Planning inquiry Supplementary Statement.

Land East of Hawksworth and Northwest of Thoroton,
Nottinghamshire, NG13 9DB.

On behalf of Renewable Energy Systems (RES) Ltd.

Appeal Ref: APP/P3040/W/23/3330045 | LPA Ref: 22/02241/FUL

Figure 1 – Key plan illustrating locations of cross sections

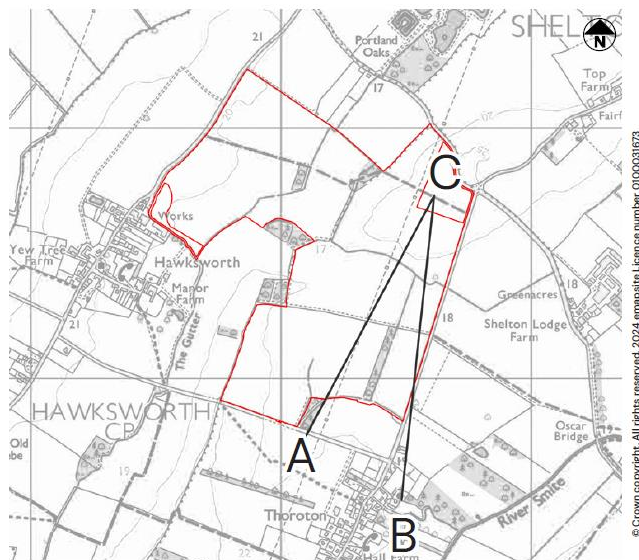
Cross sections (bare earth) through the appeal site from the highest section of Bridleway BW6 towards (a) St Helena spire and (b) Pylon 3.

- 1.30. The two requested cross sections have been prepared on drawing ref P24-0105_EN_28, attached as Appendix 5.
- 1.31. The drawing includes the following key plan (figure 1) as an inset, confirming the locations of the cross sections.
